MIL-E-1/1329(SigC)
AMENDMENT-3
8 August 1966
SUPERSEDING
AMENDMENT-2
1 December 1960

INDIVIDUAL MILITARY SPECIFICATION SHEET

ELECTRON TUBE, MAGNETRON, PULSE
TYPE 7521

This Amendment forms a part of Individual Military Specification Sheet MIL-E-1/1329(SigC), 14 January 1960.

FIGURE 1. Outline and dimensions.

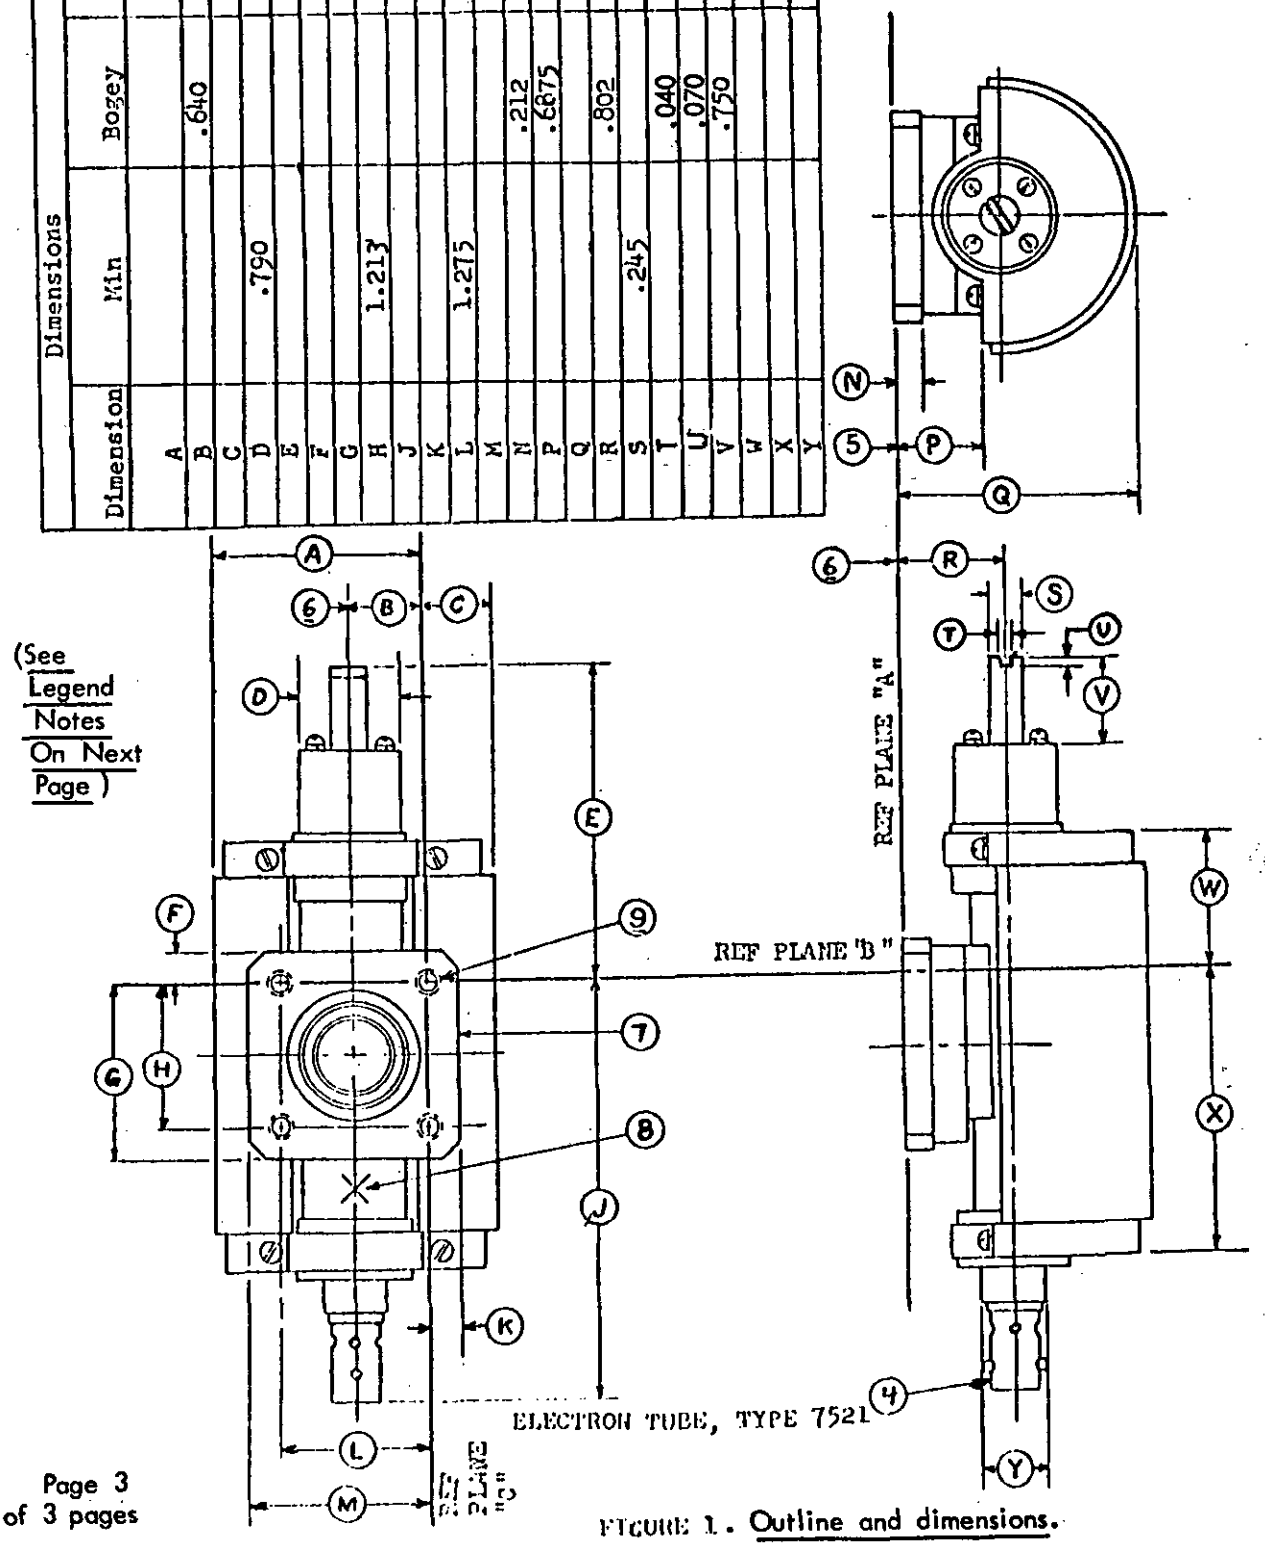
Page 7, Figure 1: Replace with new Figure 1, attached.
